Serial Number 10/617,796

AMENDMENTS TO DRAWINGS

ANNOTATED MARKED-UP DRAWING SHEET

FIG. 2

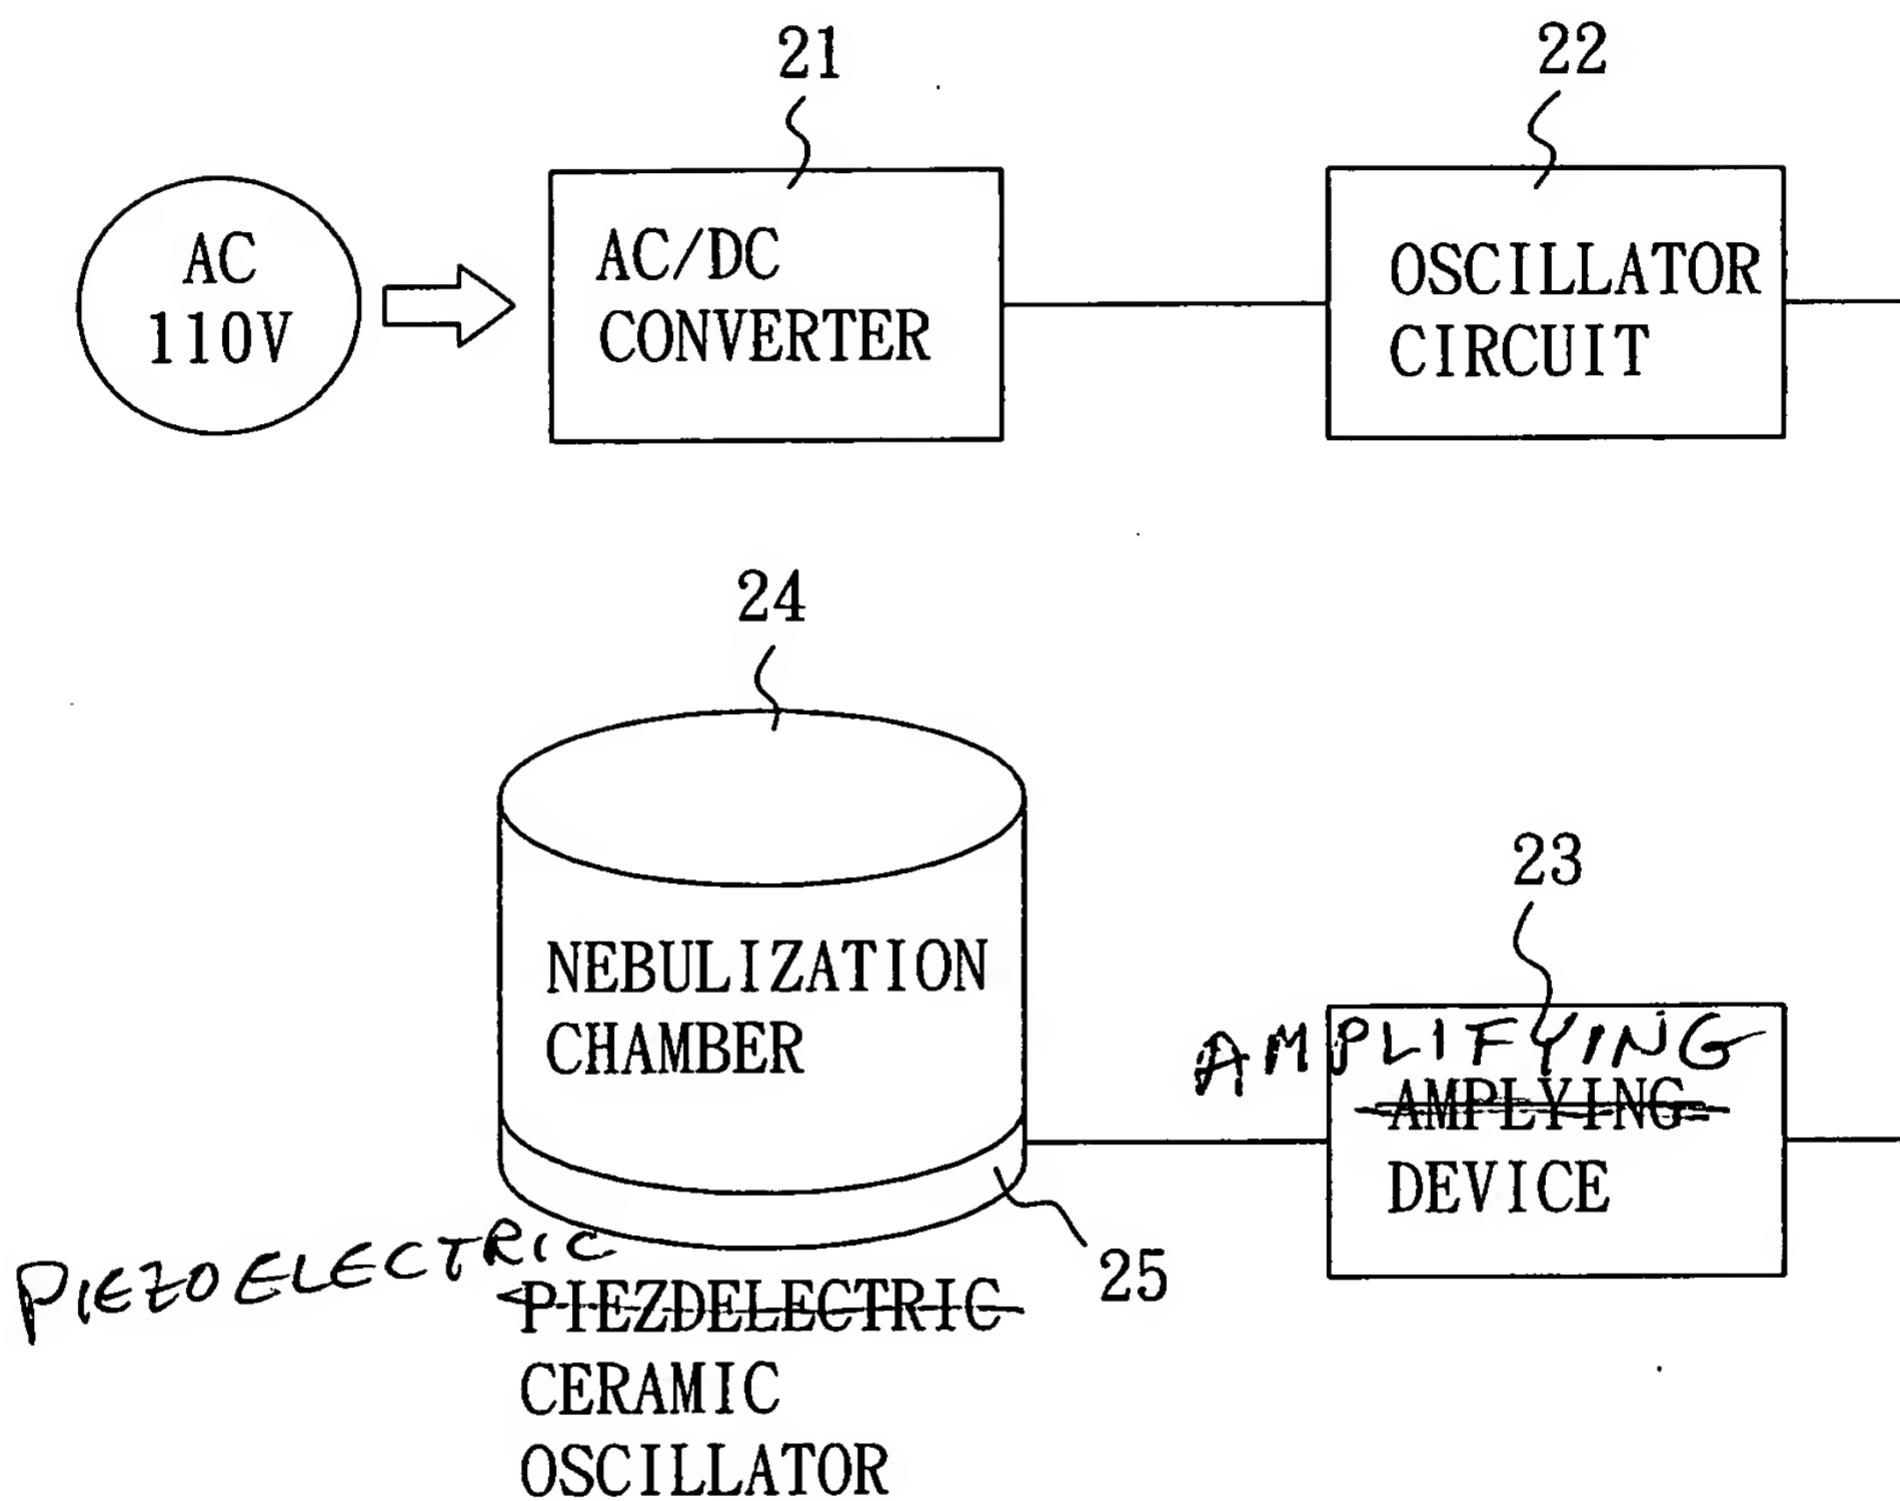
Please amend Fig. 2 by changing the caption for element 25 to read –PIEZOELECTRIC– rather than “PIEZDELECTRIC,” and by changing the caption for element 23 to read –AMPLIFYING– rather than “AMPLYING,” as marked in red on the attached ANNOTATED SHEET and included in the attached REPLACEMENT SHEET.
